# Request for Review of Airservices Australia's Responses Regarding Flight Path Change Proposal (3015)

By *Dr Anahita Sal Moslehian* PHD, EDAC

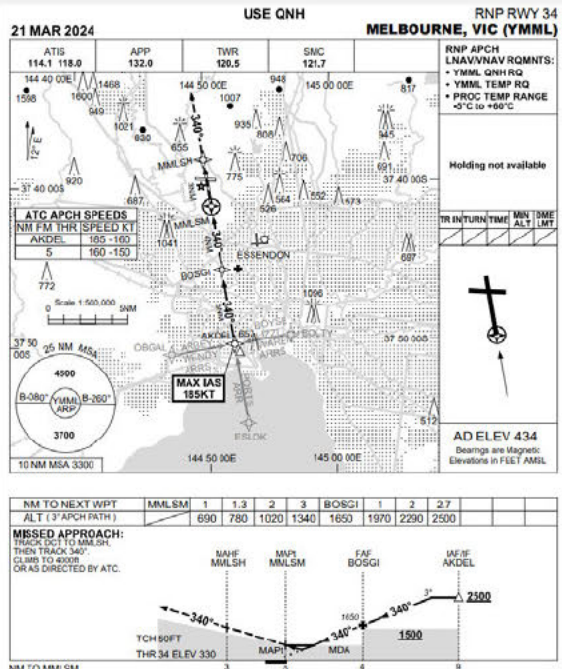
### 1. Required Distance:

The ASA's calculations are based on the required distances for an aircraft to descend at a **3-degree angle from 2,500 feet**, with an estimated distance of approximately 10 Nautical Miles (18.5 km).

Yet, the calculations show that the required distance for a descent from 2,500 feet should be 14.54 km, which is notably less than the provided estimation.

$$\text{Distance}_1 = \frac{2500}{\tan(3^\circ)}$$

Figure 1: Comparison of the turning point location for the North-South Runway versus the East-West Runway

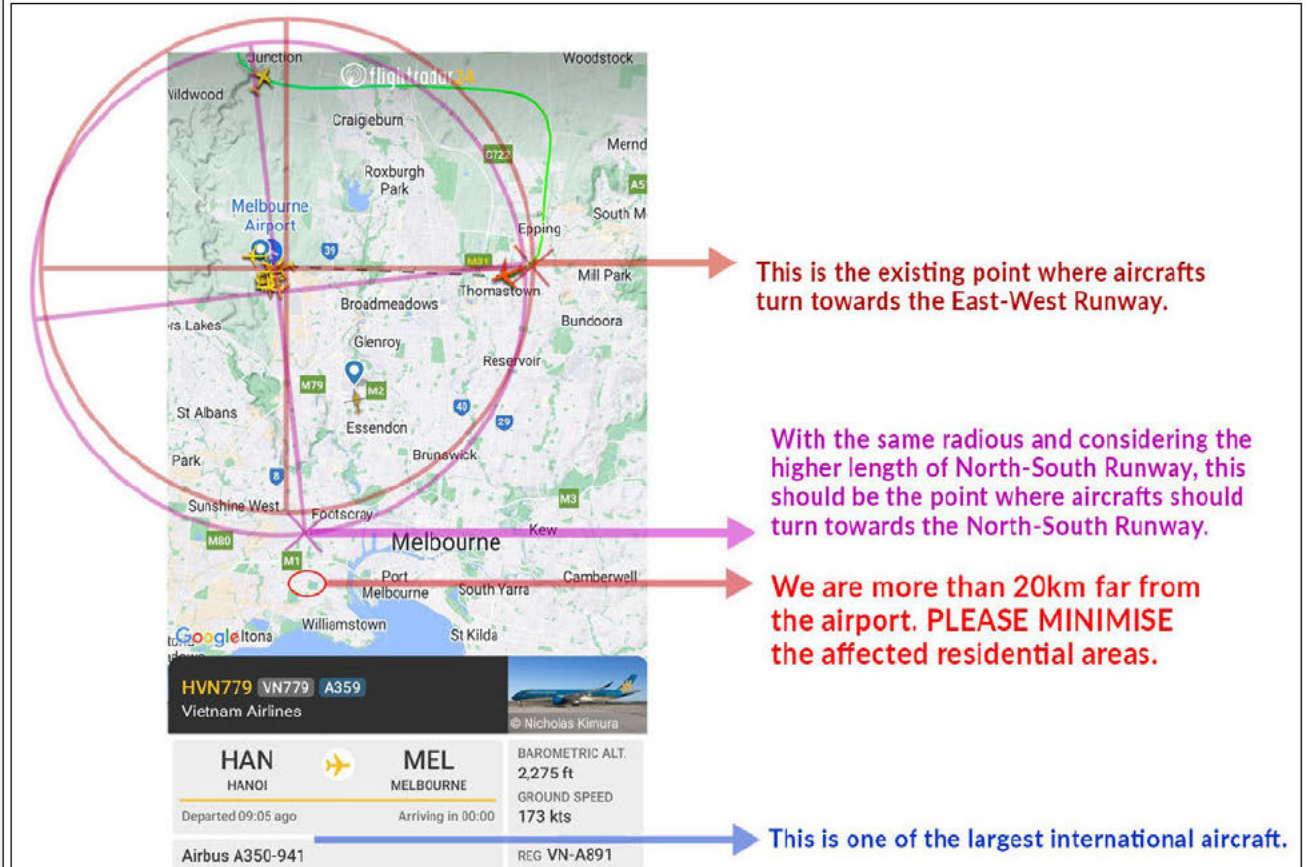
We mapped circles with the radius of the turning point distance towards the East-West Runway and replicated the circle by placing the centre at the beginning of Runway 34. This revealed significant differences (see Figures 1 and 2). We are curious to understand why the situation for the North-South Runway differs from that of the East-West Runway.

The geographical conditions are similar, with the notable exception that the North-South runway is significantly longer. Additionally, Runway 34 is used for landings when there is northerly wind, which significantly assist the landing process.

Figure 2: Please consider using the same approach for the North-South flight path design

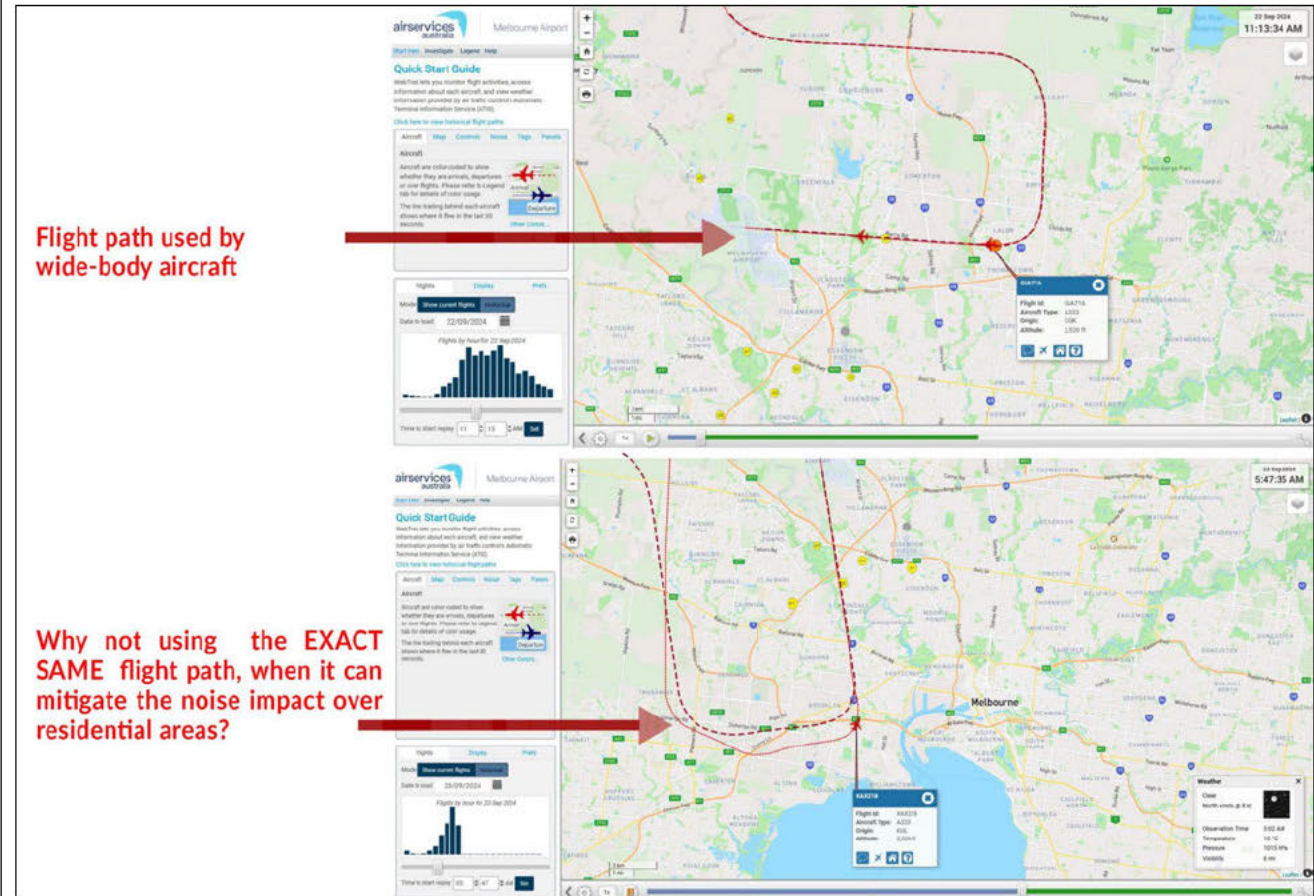
We also duplicated and rotated the exact flight path used for the East-West Runway, aligning it with Runway 34. This adjusted turning point passes over industrial areas and the M1 freeway, which could help mitigate noise impacts for over 3,000 dwellings.

While we understand this is a simplified approach, we hope it highlights the potential for reconsidering the current flight path.

Figure 3: Demonstrating HIGH VOLUME of arrivals towards Runway 34, and no departure from the West

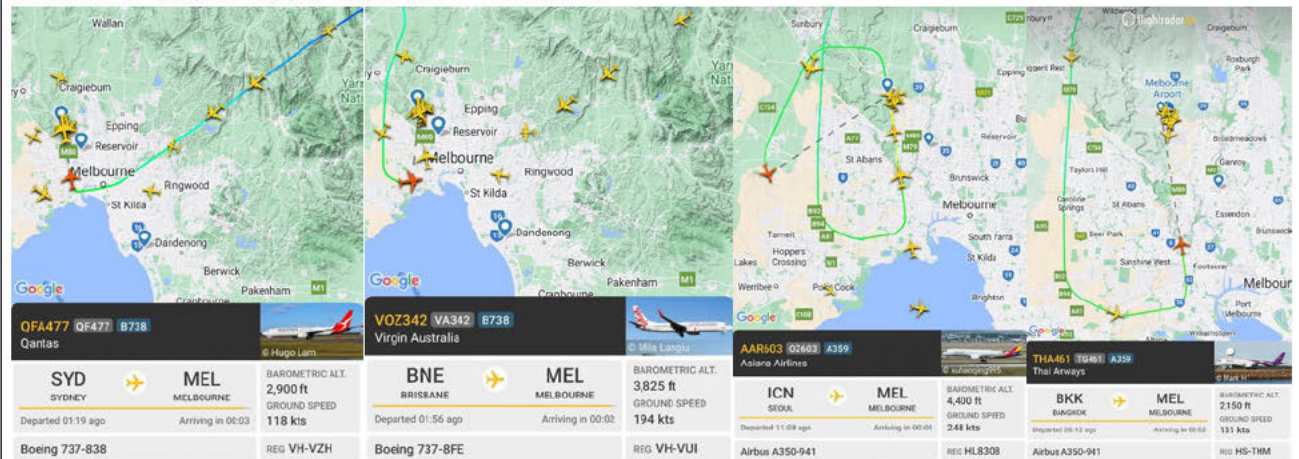
It is evident that aircraft are directed toward Runway 34 when there is a northerly breeze or wind to avoid landing with a tailwind. While departures occur from Runway 27, this does not happen during strong northerly winds, when we experience over 200 events per day. In these cases, all aircraft take off from the north, and the concern re the need for "vertical separation due to a high volume of departure flight paths to the west and northwest" may not apply under these conditions.

Figure 4: Demonstrating two inconsistent design approaches for one type of aircraft

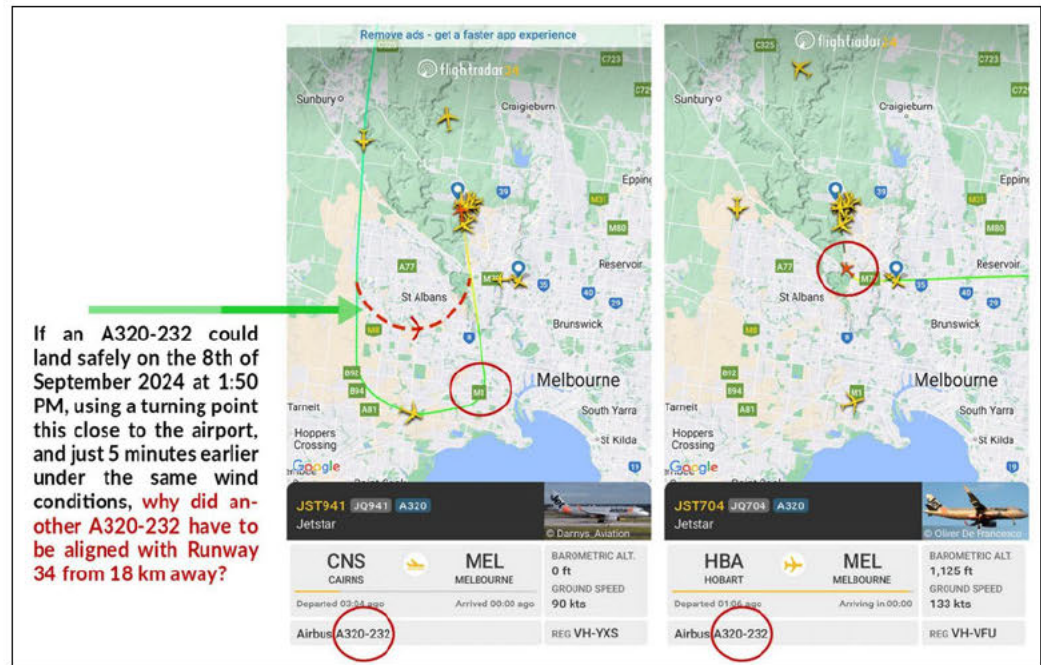
Moreover, inconsistent flight approaches raise concerns about the necessity of long-distance alignments with runways when closer turning points are demonstrably safe and feasible under similar conditions. If certain aircraft can safely land using more efficient, shorter approach routes, it is unclear why other planes of the same model are required to align from significantly farther distances, especially when weather and wind conditions are comparable.

For example: *If an A320-232 could land safely on the 8th of September 2024 at 1:50 PM, using a turning point this close to the airport, and just 5 minutes earlier under the same wind conditions, why did another A320-232 have to be aligned with Runway 34 from 18 km away?*

We kindly request that you consider the needs of the residents affected by the flight paths and explore the provision of another flight path over industrial areas (highlighted in red in Figure 4, OR the suggested adjustment to the current path).

Figure 5: The turning point towards the Runway 34 from the Eastern suburbs – for A320 and B737

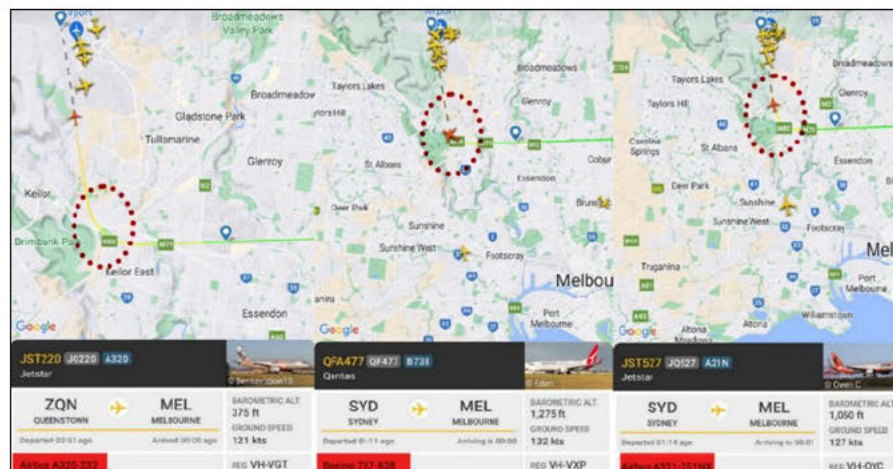
While we understand the need for aircraft to align with the runway before landing, we have observed that similar aircraft occasionally turn towards Runway 34 from the eastern suburbs at a point much closer to the airport, which results in fewer affected residential areas (Figure 5). We respectfully request a re-evaluation of the flight paths for the western suburbs to achieve similar noise mitigation benefits (Figure 6).

Figure 7: The four main flight paths from the east and west merge over one residential area - far from the airport

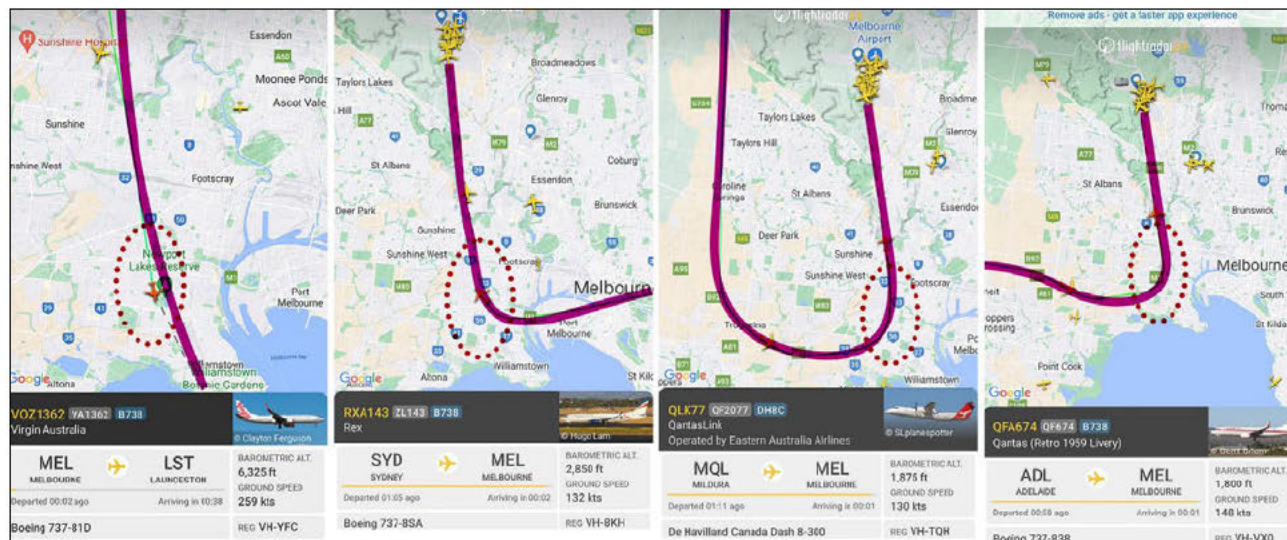
It seems that the current approach favours a single path for all aircraft types, primarily for operational efficiency. As a result, residents in our area are subjected to hundreds of flights overhead.

- Isn't noise sharing one of the fundamental principles of Airservices Australia? Why is this principle not being implemented in our area?
- Why must we endure more than 200 flights during dry days with northerly winds, which occur very frequently?

Residents of East Melbourne have also reported over 100 flights in their submission for Sanat Inquiry to Aircraft Noise. Those flights arriving from Sydney alone. Adding international flights, as well as flights from Perth, Brisbane, Adelaide, and Tasmania, could mean that we are dealing with over 200 events per day. It is impossible to count them all as they pass over every 2-5 minutes, one after the other. Please see the following screenshots:

Figure 12: Shifting the turning point slightly to the industrial areas and M1

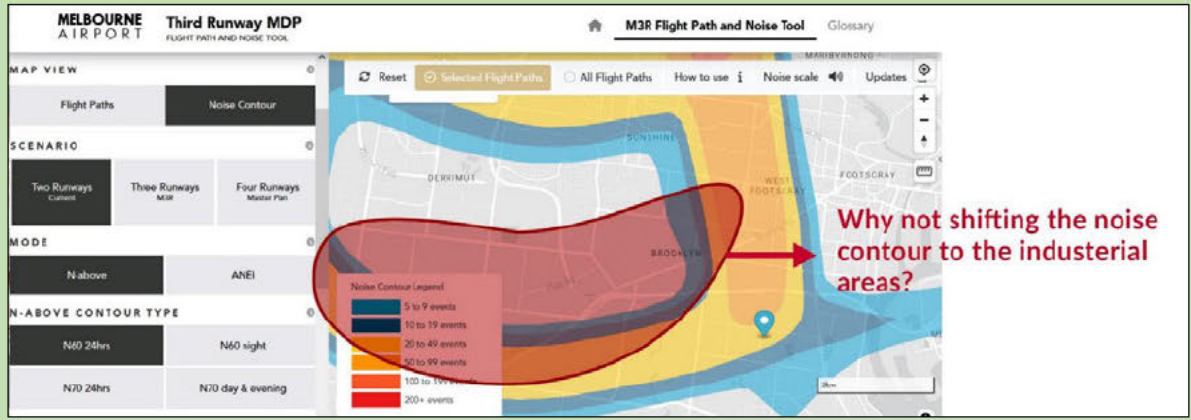
Suggestion 1: As shown in Figure 12, this report proposes a **minor adjustment** to the current flight path, diverting aircraft over the **M1 and industrial areas**. The redirecting aircraft over the industrial areas of Laverton North towards the industrial areas of Brooklyn and Tottenham, and then directing them towards Runway 34.

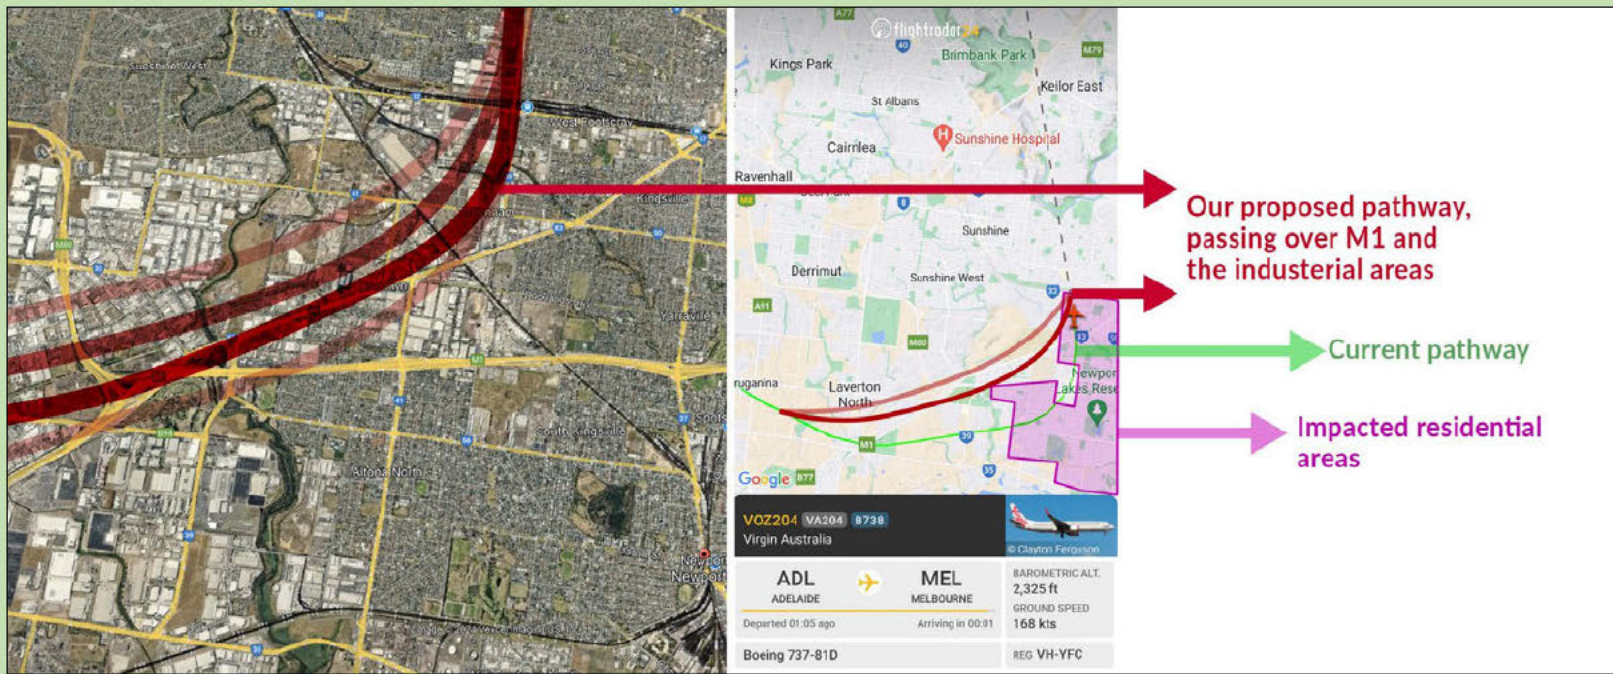
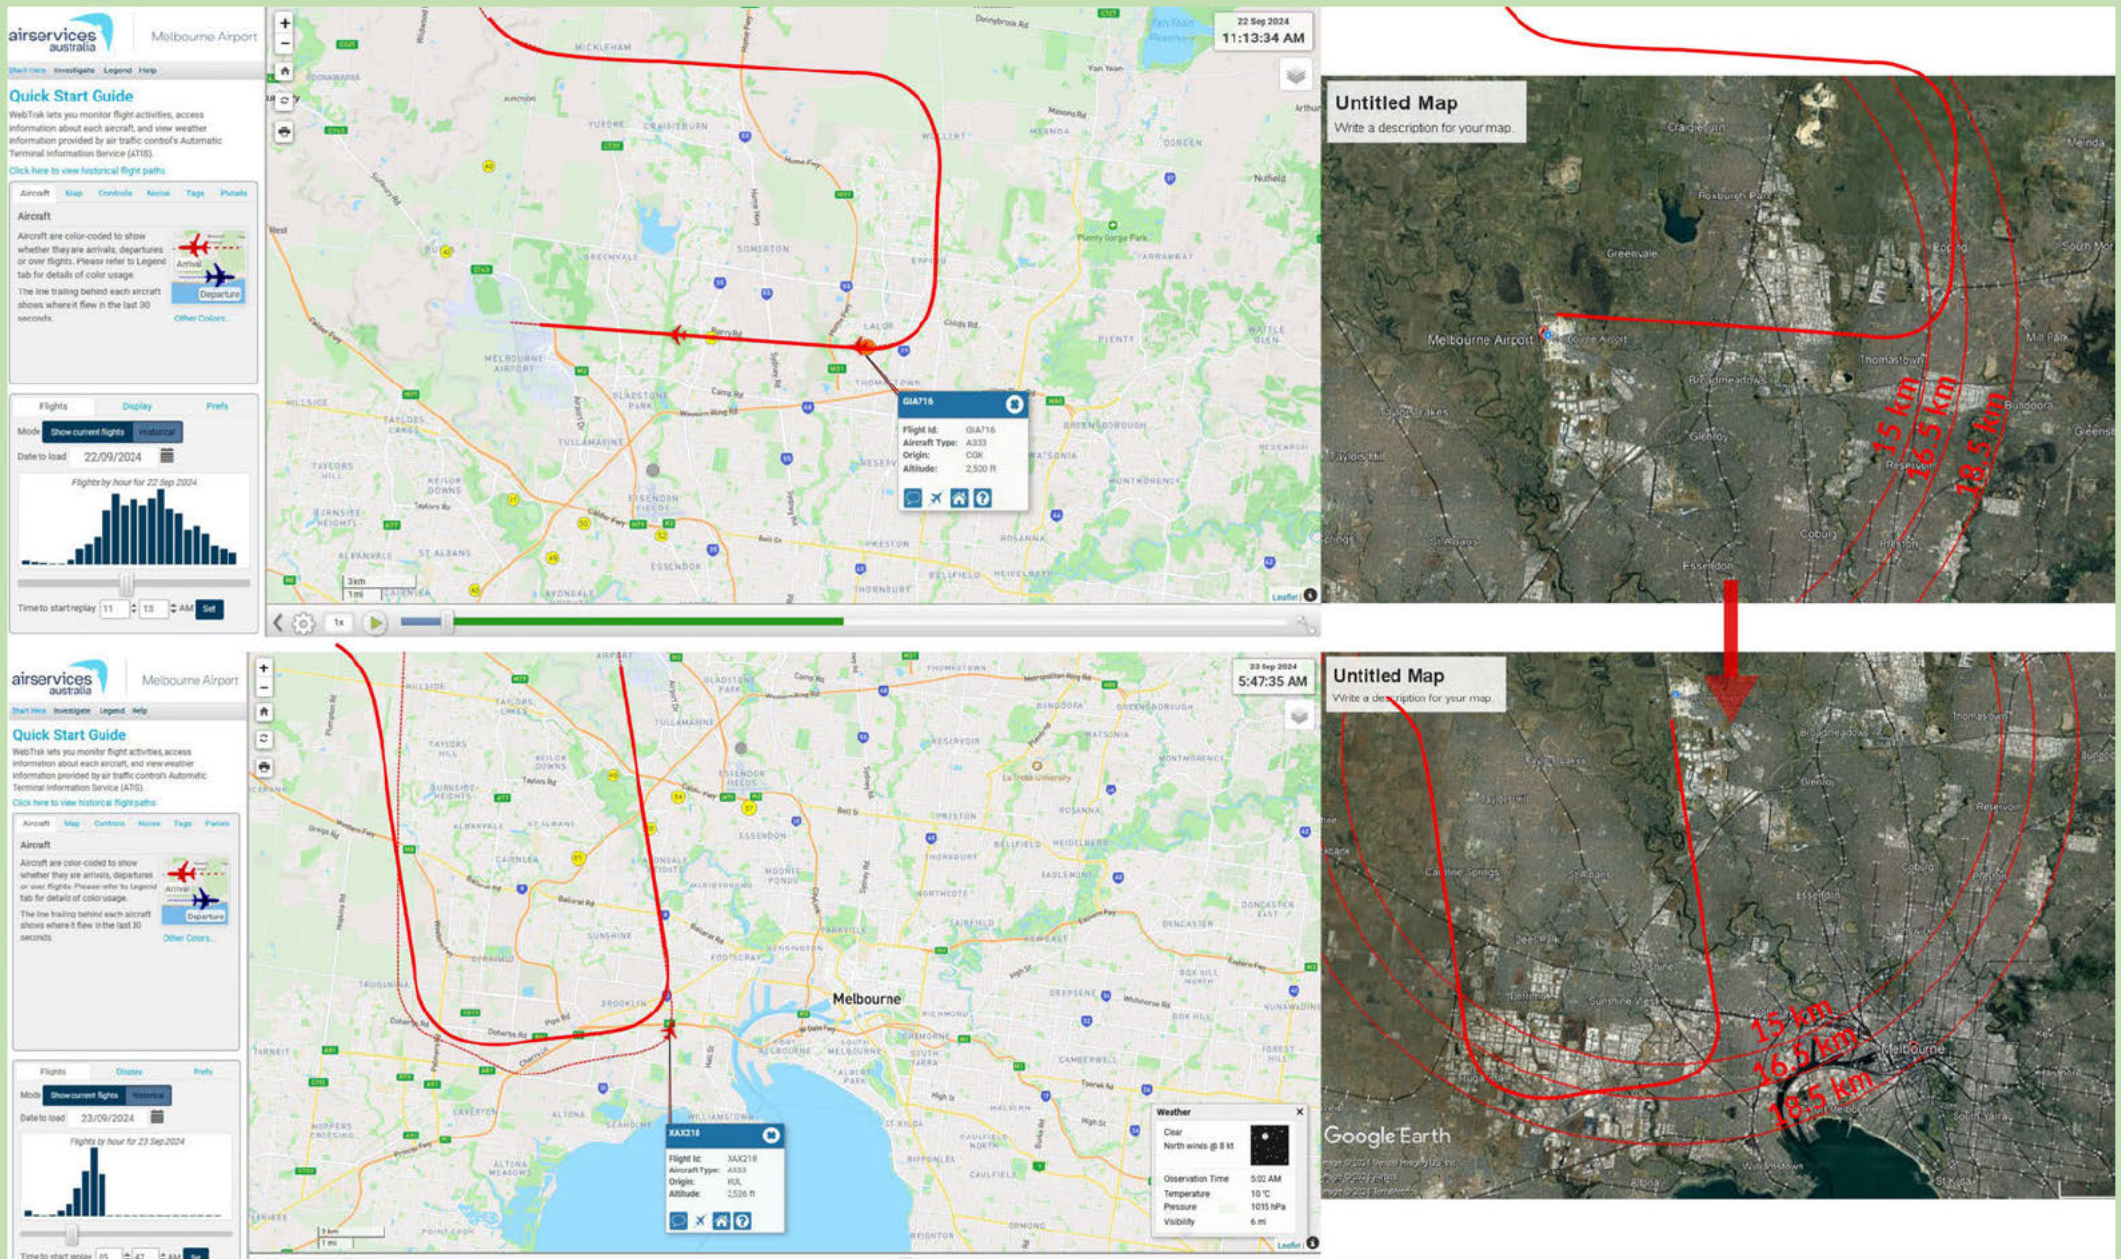
**Figure 13: Taking the same approach used for the design of East-West Runway: as shown in the diagram, if we replicate the same flight path, the turning point will be at a 15-16 km distance from Runway 34, instead of 18.5 km. This adjustment allows the flight path to overfly the industrial zone, minimizing the impact on residential areas. Please consider introducing this path for the majority of aircraft landing on Runway 34.**
